Glen Innes to Tamaki Drive Shared Path: Summary of your feedback on Section 2 (St Johns Road to Ōrākei Basin)

February 2019

Connection to Section 1

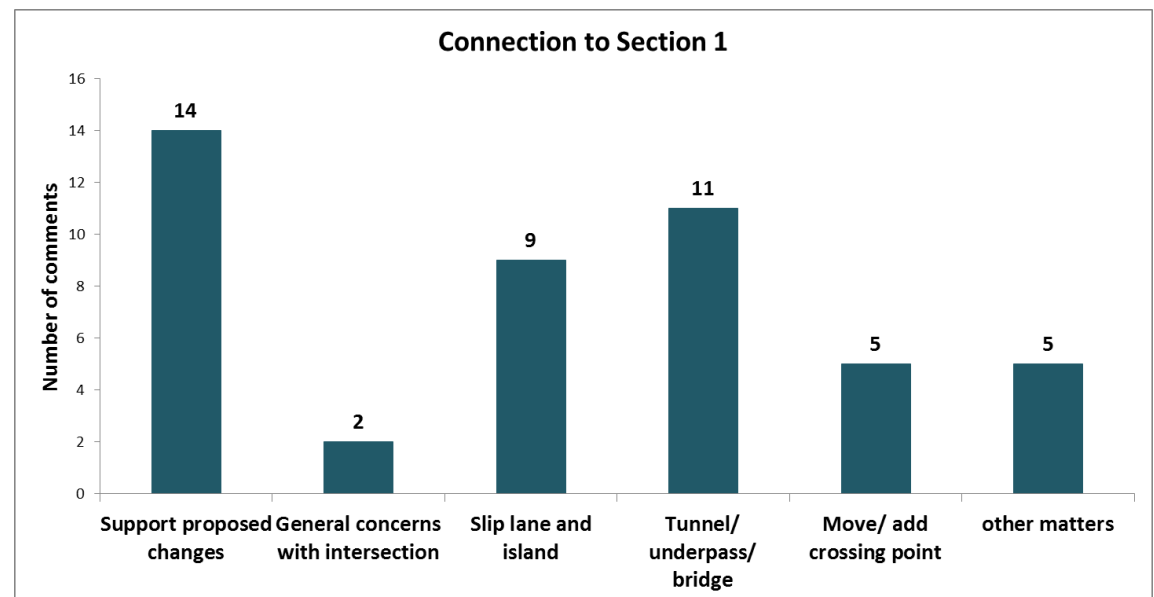
46 of you commented on this connection (21% of those commenting on connections); many of you noting that the intersection was difficult to cross and unsafe. 14 of you welcomed the proposed changes and two expressed residual (general) concerns. In addition, there were 30 requests for further specific change:

- 11 of your comments expressed a desire for a grade separated crossing such as an underpass or bridge (one person noting an underpass would also assist horse riders).

- We received nine requests for the removal of the slip lane or raising questions around the suitability of the island. The slip lane was generally seen as unsafe, and the enlarged island insufficient for cyclists and horses.
- There were five requests to move the crossing or to add a crossing on the northern side of the intersection. Other comments included your identified need to provide better cycling access along the adjacent connecting roads (e.g. St Heliers, West Tamaki Roads) as these were narrow in places and made accessing the path dangerous.

Aspect	Number of comments (break-down within theme)	Feedback points	Auckland Transport/NZ Transport Agency response
Route (Section 4)	2	<ul style="list-style-type: none"> ▪ Prioritise Section 4 (1) ▪ Interim solution required for Section 4 (1) 	<p>The routes along the railway lines for Section 4 were discounted as part of an earlier process and so have not been considered further.</p> <p>The design for Section 4 is in development and we are aiming to complete both Section 2 and 4 by the end of 2021.</p>
Connections	29	<p>Connection with Section 1 (St Heliers Bay Road and St Johns Road intersection):</p> <ul style="list-style-type: none"> ▪ Grade separate intersection (11) ▪ Remove slip lane (9) ▪ Move crossing/add crossing on north of intersection (5) ▪ Provide zebra crossing (1) ▪ Widen/ improve cycling access on St Heliers Bay Road (1) ▪ Improve cycling access on West Tamaki Road (1) ▪ Stop changing/disrupting intersection (1) 	<p>The pedestrian crossing over the slip lane on St Heliers Bay Road will be 5.4m wide and it will be a raised crossing. Half of the crossing will be green for people on bikes and half of it marked with zebra stripes for pedestrians.</p> <p>Removing the slip lane and adding additional pedestrian crossings would have a major effect on the operation of the intersection and a change of this scale needs to be addressed as part of a broader work programme, taking into consideration to traffic flow in the wider area. This is not within the scope of this project and any major changes will be addressed through the <u>Integrated Corridors Programme</u>.</p> <p>The size of the traffic Island will be increased by 250%, from</p>

Aspect	Number of comments (break-down within theme)	Feedback points	Auckland Transport/NZ Transport Agency response
			<p>13m² to 46m². (measured as the path area, not the whole area of the island). This will provide a good amount of space for people on bikes and on foot.</p> <p>Improvements to surrounding cycling infrastructure, such as on West Tamaki Rd, are not within the scope of this project. There are no current plans for plans for cycling improvements on West Tamaki Road. This area is not identified in the Cycling Programme Business Case as 'priority area', however cycling improvements here may be undertaken as part of other transport projects.</p>
	153	<p>North-South connections:</p> <ul style="list-style-type: none"> ▪ Increase access (19) ▪ Access to: <ul style="list-style-type: none"> – Eastridge shops (8) – schools (46) – train station from Kepa Rd (8) – Kepa bush (5) – Purewa Cemetery (2) 	<p>We acknowledge that the community are eager to have north-south connections through the reserve. While connections to the shared path are not in the scope of this project, when designing and constructing the shared path, care is taken to ensure that future connections are possible. Auckland Transport and Auckland Council are responsible for local links and are working with the local board on links in some areas. Available budget and prioritisation are issues</p>

Lighting

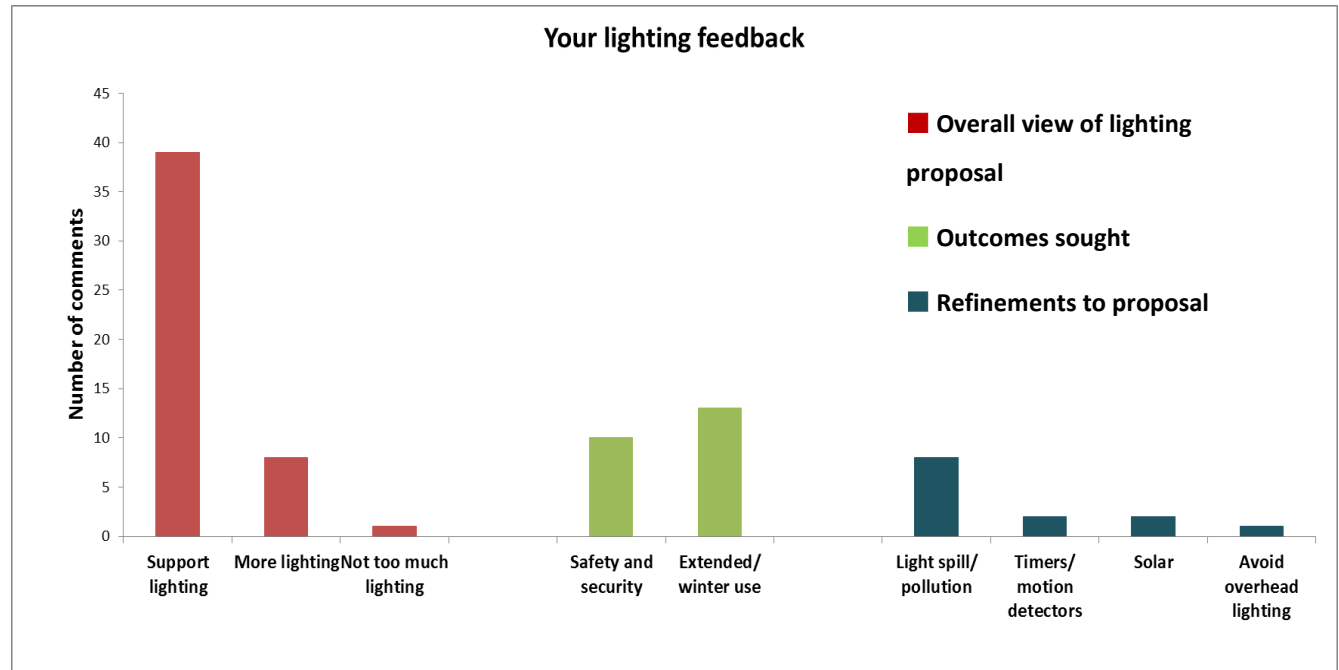
supportive of our proposed approach and underlined our identified objectives of improving both safety and the use of the path. Eight of you wanted to see more lighting, and one person cautioned that there should not be too much lighting.

We received 13 suggested refinements to the lighting proposal; most of these (eight) were concerned with light spill into neighbouring properties, light pollution effects upon the surrounding bush, and the brightness of LEDs. We received one request that there be some illumination a short distance beyond the path to assist with security and safety. Closely related to this were two suggestions to install timers or motion detectors. Two of you encouraged the use of solar powered lighting, and one requested we avoid overhead lighting and use low-level lighting instead.

Aspect	Number of comments (break-down within theme)	Feedback points	Auckland Transport/NZ Transport Agency response
		<ul style="list-style-type: none"> Address potential light spill into properties neighbouring the path, light pollution, brightness of LEDs (8) Install timers/motion detectors (2) Use solar lighting (2) Avoid overhead lighting/use low-level lighting (1) 	<p>lighting under the handrail, which means light spill will be minimal on adjacent properties.</p> <p>Alongside the concrete sections of the path we will install lighting columns, which will be angled to ensure light does not spill onto neighbouring properties. Once we have determined where lighting columns are likely to go, we will share plans with adjacent neighbour/s.</p> <p>LED lighting will be used in handrails on bridges and boardwalks and LED luminaires on the lighting columns. LED lights have significantly longer life expectancy than other types of lighting, they use a fraction of the power consumption of incandescent lighting, and provide a more natural spectrum compared to sodium lamps.</p>

Landings

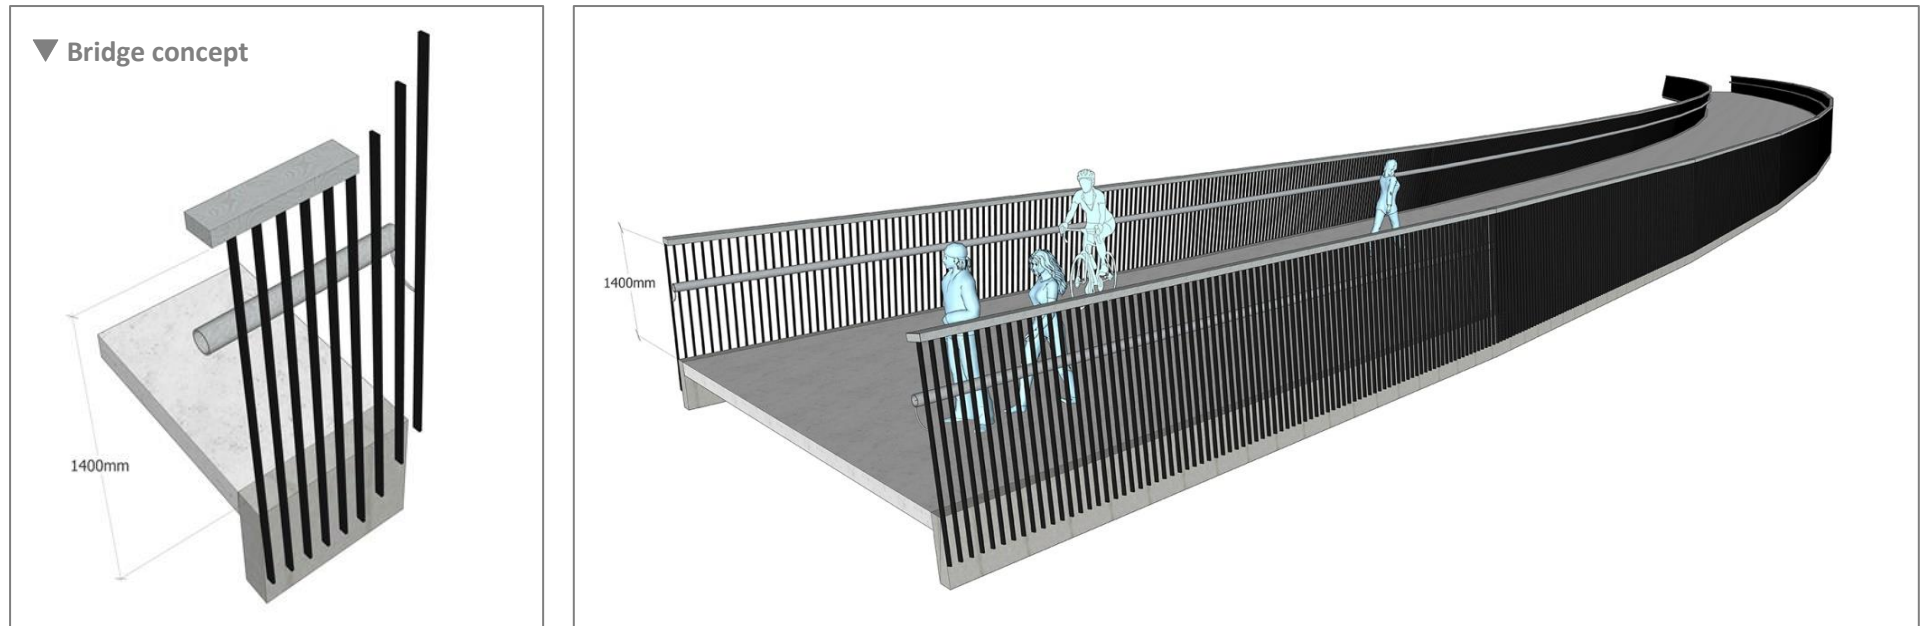
- have landings as a lay-by or across only part of the path (3);
- ensure the landing design does not compromise safety (2);
- make the landings as far apart as possible (1).
- make sure the landings provide refuge as intended (2);
- mark the landings to indicate a change in slope (2);

“The landings should be visually indicated with markings on the surface - hitting them unexpectedly on a downhill will cause jarring of the joints and possibly falls.”

Aspect	Number of comments (break-down within theme)	Feedback points	Auckland Transport/NZ Transport Agency response
		(2).	include creating connections to the shared path. Tahapa Reserve East will serve as a key access point and laydown area for the duration of our construction works. We are working with Council to coordinate these works.
	3	<ul style="list-style-type: none"> ▪ Include 'Maori features' (2) ▪ Not sure about Maori features/include other stories (1) 	Auckland Transport has engaged Maori artists (kaimahi toi) to design cultural artworks for the project. These elements are still being developed in consultation with mana whenua but are likely to include pou, carved handrails, concrete stencils in the path and perforated metal in the rail overbridge.
Engineered elements	36	<p>Landings:</p> <ul style="list-style-type: none"> ▪ resolve feedback on landings (15 for: 15 dislike/have concerns) ▪ have landings as a lay-by or across only part of the path (3); ▪ ensure the landing design does not compromise safety (2); 	<p>We listened to feedback about the spacing between landings on Section 1 and have designed longer, more widely-spaced landings for Section 2. This should provide a smoother ride for people on bikes and people using mobility aids.</p> <p>A different finish on the landings is proposed to provide a visual cue to path users. The finish on the landing will be</p>

Aspect	Number of comments (break-down within theme)	Feedback points	Auckland Transport/NZ Transport Agency response
		<ul style="list-style-type: none"> make the landings as far apart as possible (1) 	<p>dark exposed aggregate concrete and on the path it will be lighter grey concrete with a 'broom brush' finish.</p> <p>The spacing of landings varies depending on the gradient. For steeper gradients, the landings need to be more closely spaced. The shortest distance between landings is 10 metres — this is in a short, 80 metre section. Otherwise the typical spacing is 45 metres or more, compared to a nine metre spacing on Section 1.</p>
	53	<p>Bridges and boardwalks:</p> <ul style="list-style-type: none"> Make bridges a feature (2) Change bridge decking (1) Change boardwalk decking (8) Minimise height/extent of balustrades (17) Balustrades consistent across project (5) Change balustrade materials (12) Balustrades dark/black/natural colour (3) Use non-slip surfaces (6) 	<p>The fibre reinforced plastic decking we propose on the boardwalk sections has been selected for its durability and grip. The bridges will have concrete decks. Concrete is also durable, has good grip and slip resistance, and is low maintenance.</p> <p>Balustrades will be used where the path is on a steep gradient - this provides for mobility impaired users to be able to hold onto a handrail and also where there is a fall from height risk (to protect people from falling down a steep</p>

Bridges and boardwalks

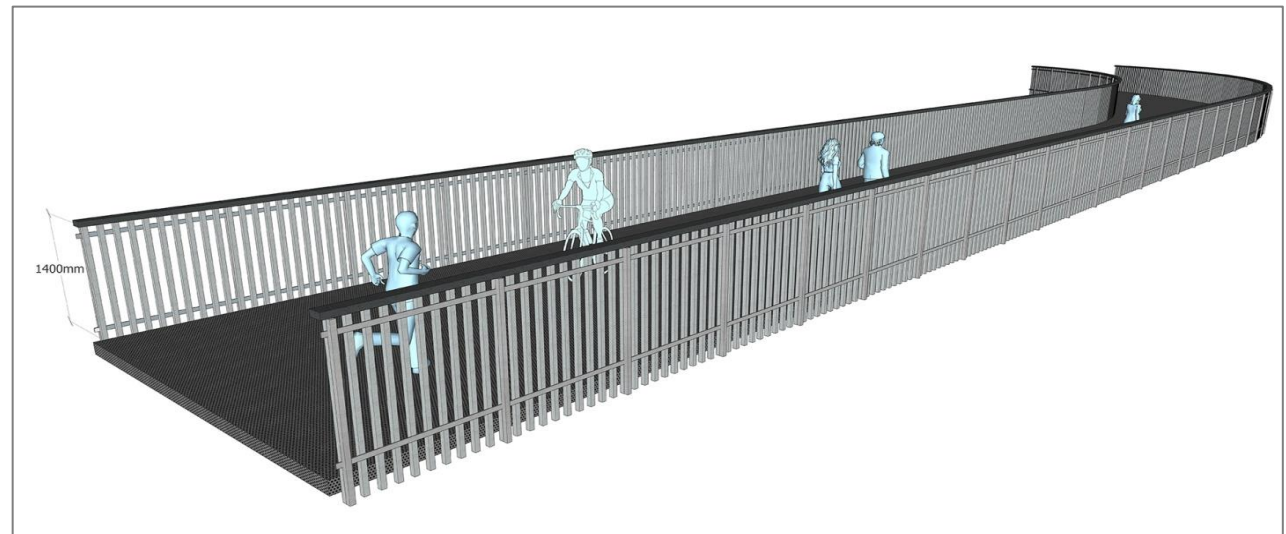
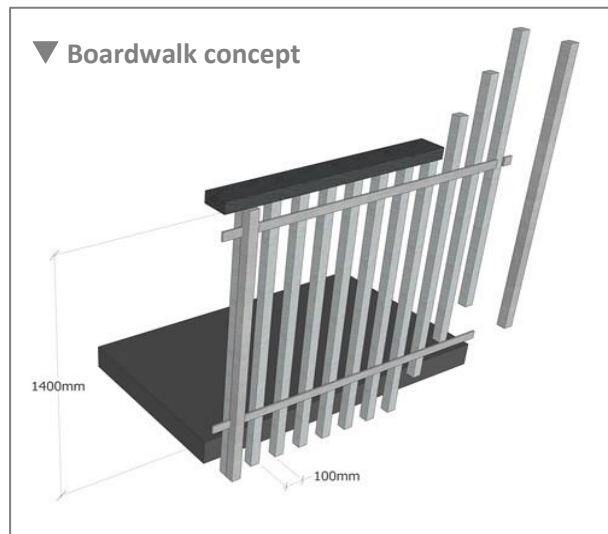
"The board walks and bridges will make this a really attractive ride - they seem to be well thought out. It should be quite a spectacular ride when it's done."

"I don't like the boardwalk and bridge railing designs. I think they are too high and obscure the beautiful view."

"I think railing style should be consistent to what you have on the boardwalk."

Aspect	Number of comments (break-down within theme)	Feedback points	Auckland Transport/NZ Transport Agency response
			<p>slope / drop).</p> <p>We are reviewing the 1.4m balustrade height for Section 2 to see if there are areas where this can safely be reduced to 1.2m and are considering factors such as the straightness of the path, forward visibility, lighting and presence of hazards (e.g. one of the bridges crosses over the railway lines which are electrified). We will be sharing the final design with you and balustrade height/s will be confirmed at this time.</p>
	6	<p>Fences:</p> <ul style="list-style-type: none"> Make fence smaller and less obstructive, not post and wire (5) Make fence more substantial (1) 	<p>We are working with the Pony Club to ensure the post and wire fence in this location is suitable for horses.</p>
	15	<p>Path:</p> <ul style="list-style-type: none"> Path not wide enough (2) Path too wide (1) More detail required (3) Off path space to run on (1) 	<p>The shared path will be mostly 4m wide, increasing to 4.5m on boardwalks and bridges, which is consistent with the widths on the other sections of the route.</p> <p>The paths will be concrete, which is durable, has good grip and slip resistance, and is low maintenance.</p>

Fencing

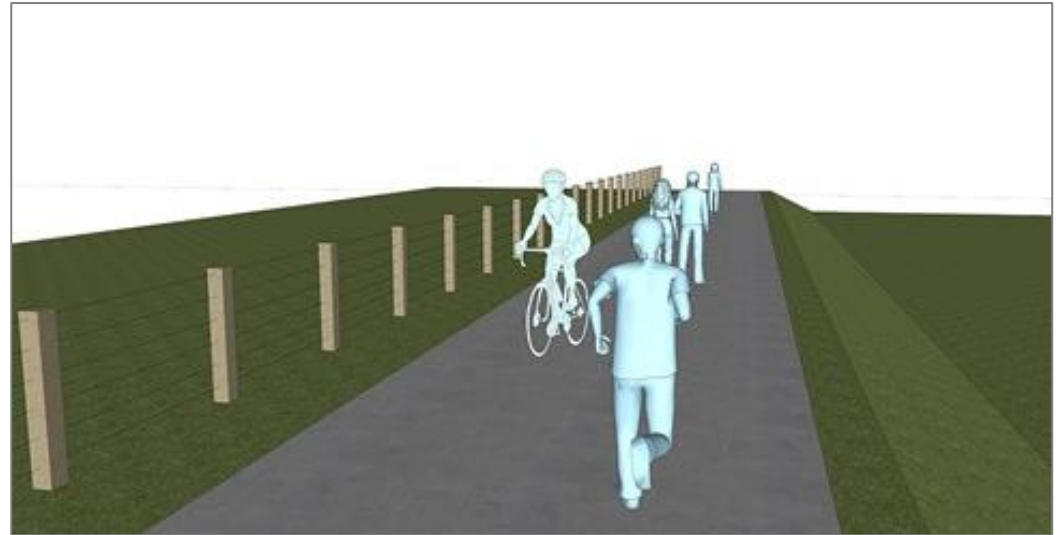
- Seven of you liked the proposed fence because it would not be intrusive and would give “*good visual permeability and connection to this 'rural' land*”, and was in keeping with the pony club context.
- Five of you thought a different approach was required and that the fence should not be a post and wire fence, that it was too high/should be even smaller and “less obstructing to the eye”. By contrast, one person thought the fence should be made more substantial.
